SERVICE BULLETIN

SERVICE BULLETIN		No.: MSB-99E42-003	
		Date: 1999-12-31	<Model> <M/Y>
Subject:	CHANGE IN DOOR ADJUSTMENT PROCEDURES		(EC,EXP) GALANT 96-10 (EA0A) 96-10
Group:	BODY	Draft No.: 99AL040911	(EC,EXP) SPACE RUNNER 97-10 (N10,20,30,40) (EC,EXP) SPACE WAGON (N80)
INFORMATION	INTERNATIONAL CAR ADMINISTRATION OFFICE	 T.NITTA - PROJECT LEADER AFTER SALES SERVICE & CS PROMOTION

The front and rear door adjustment procedures for GALANT and the rear door adjustment procedures for SPACE RUNNER/SPACE WAGON have been changed.

DOOR FIT ADJUSTMENT

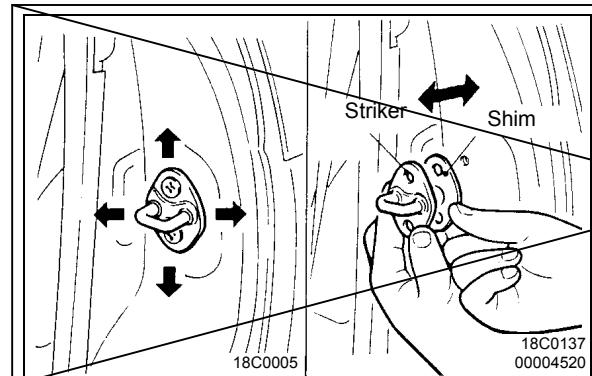
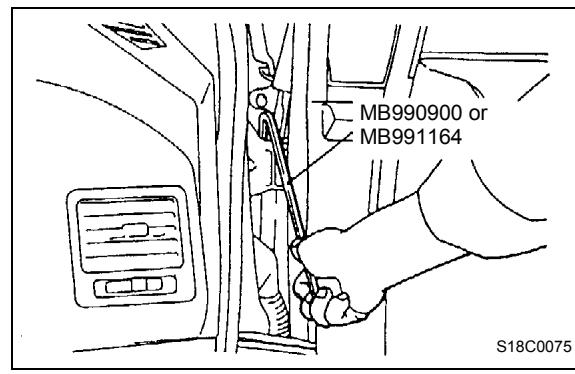
Changed to [A] on
the following page

1. If the clearance between the door and the vehicle body is uneven, affix protective tape to the fender around the hinge and to the edge of the door. Then use the special tool to loosen the door hinge mounting bolts on the body, and adjust the clearance around the door so that it becomes even.
2. If the door and the body are not flush with each other, use the special tool to loosen the door hinge mounting bolts. Then align the door.

[A]

1. If there is an uneven clearance between the door and the body, attach protective tape to the door edge, fender, or center pillars around the hinge mounting area. Use the special tool to loosen the body side door hinge mounting bolts, and move the door so that clearance around the door will be uniform.

[B]

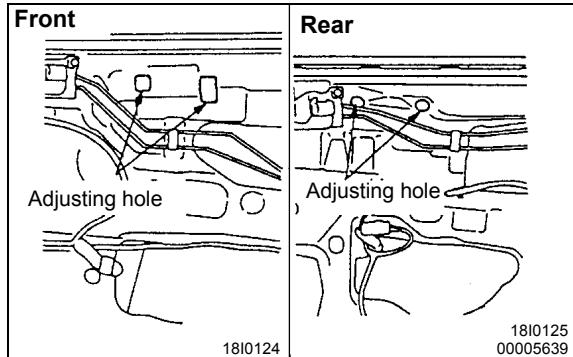
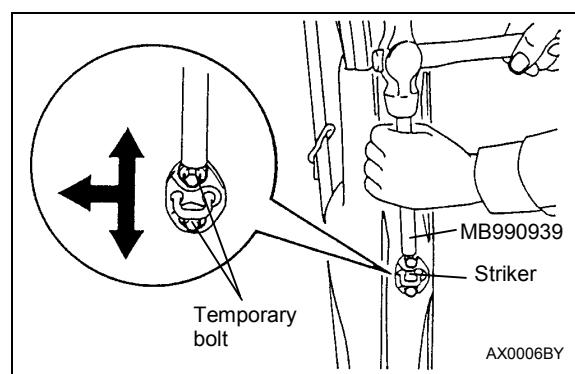
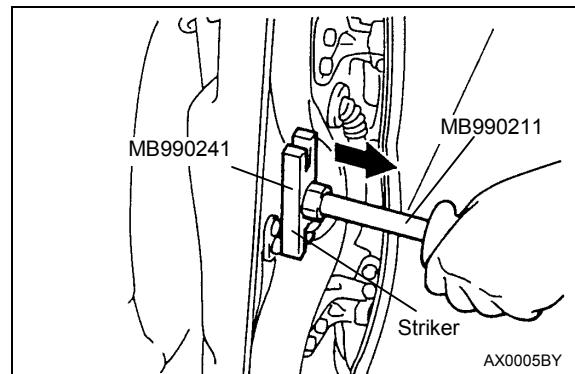
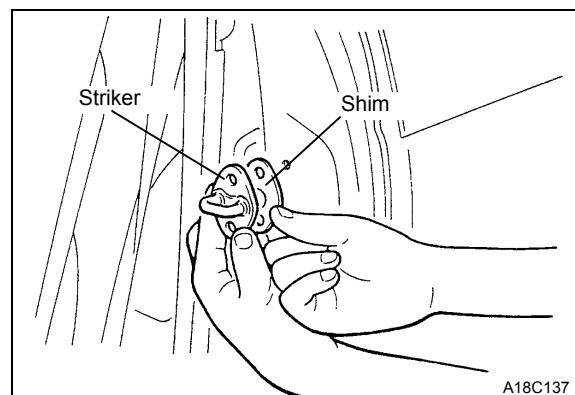
Changed to [B] on
the following page

3. If the door opening and closing is heavy, adjust the meshing of the striker and the door latch (in the longitudinal direction) by adding shims to the striker and by moving the striker up and down or to the left and the right.

3. If the opening and closing of the door is stiff
 - 1) Striker adjustment (body inside and up and down) Replace the striker mounting bolts with the temporary bolts. With the temporary bolts loosened a small amount, use the special tool (MB990939) and the hammer to tap the heads of these bolts in the direction of adjustment.

- 2) Striker adjustment (body outside) With the striker mounting bolts loosened a small amount, use the special tools (MB990211 and MB990241) to pull the striker toward the outside of the body for adjustment.

- 3) Shim adjustment (fore and aft) Using the striker mounting shim, adjust engagement between the striker and the door latch.
